PROCESS CHANGE NOTIFICATION PCN0603

Cyclone II Family M4K Memory Block Modification

Figure 1: Cyclone II Device Revision Number Identification

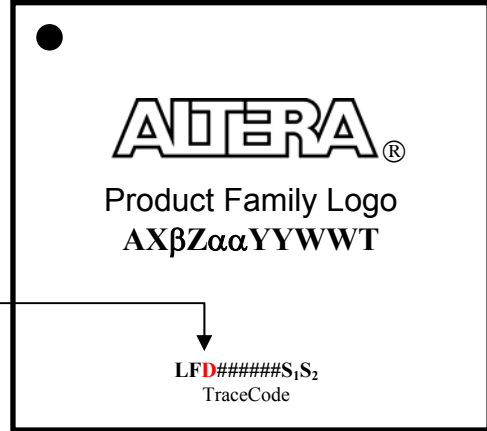
Production Cyclone II devices with the M4K memory block modification will start shipping in the second quarter of 2006. The modified devices can be identified by the revision number, as indicated in Figure 1.

Device	Modified Revision
EP2C5	B
EP2C8	B
EP2C20	B
EP2C35	C
EP2C50	B
EP2C70	B

D in position 3 of the lot number indicates revision
